Suggestion for amendment of UN Regulation No. 107 (M2 and M3 vehicles)

Glass breaking device efficiency

Picture **XX**

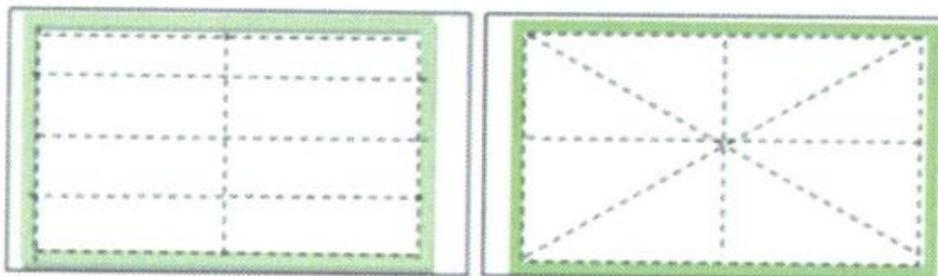
7.6.8.2.2.4 The inner surface of each emergency window may be fitted with a plastic film to enable the person to remove the window pane or panes with his hands. *[The plastic film shall be cut at the outer edge of the emergency window and following the patterns shown in picture XX below]*. In case of fitting a plastic film to the emergency exit, it shall be compatible with the device for breaking the glass and shall not reduce its efficiency. In addition, the characteristics of the approved glazing shall remain unchanged. The device for breaking the glass for the emergency windows at the rear of the vehicle shall be positioned either centrally above or below the emergency window or, alternatively, a device shall be positioned adjacent to each end of the window.

- 7.6.9.5.3** The inner surface of each escape hatch may be fitted with a plastic film to enable the person to remove the window pane or panes with his hands. *[The plastic film shall be cut at the outer edge of the escape hatch and following the patterns shown in picture XX below]*. In case of fitting a plastic film to the escape hatch, it shall be compatible with the device for breaking the glass and shall not reduce its efficiency. In addition, the characteristics of the approved glazing shall remain unchanged.
